[1] REDLINE REVISION 11/5/08

REVISION "F"

MD RTE 2 (GOVERNOR RITCHIE HWY) AND MD 710 (ORDNANCE RD)

GENERAL INFORMATION SHEET

WIRING DIAGRAM

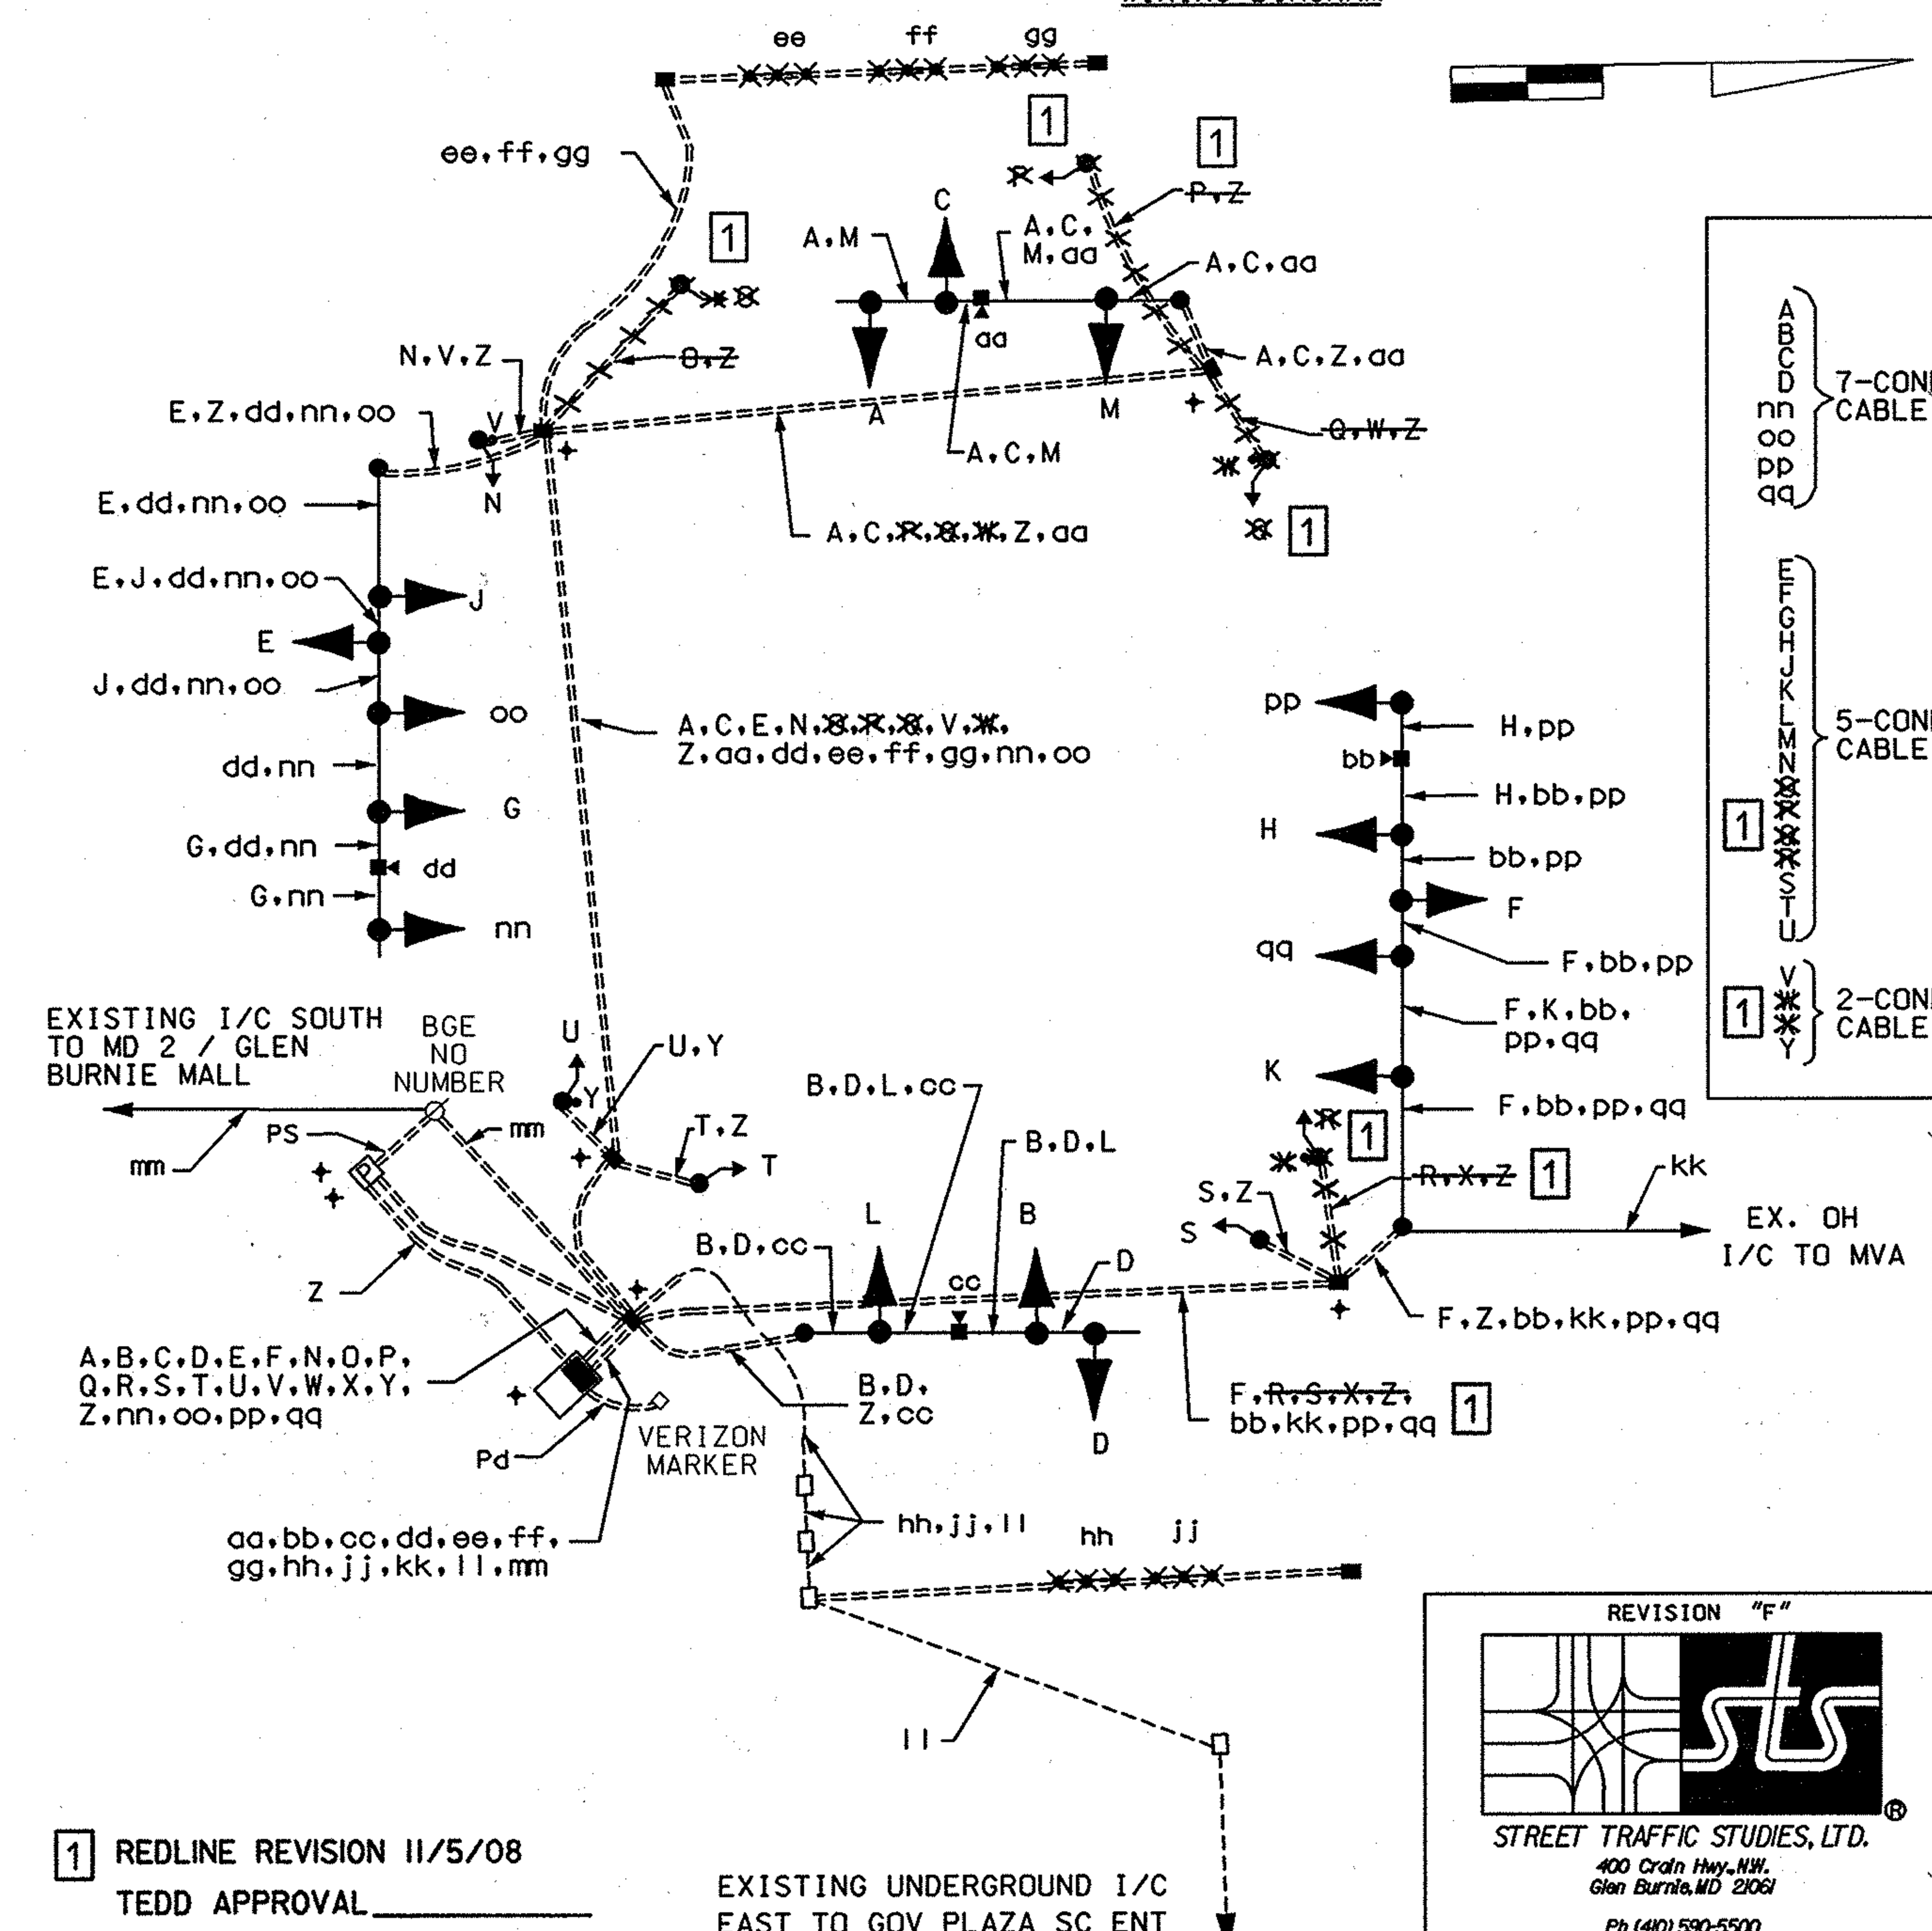
E, F, G, H, J, K, L, M, N, ~~O~~, ~~P~~, ~~Q~~, S, T, U } 5-CONDUCTOR ELECTRICAL CABLE (NO. 14 A.W.G) [1]

V, ~~W~~, ~~X~~, Y } 2-CONDUCTOR ELECTRICAL CABLE (NO. 14 A.W.G) [1]
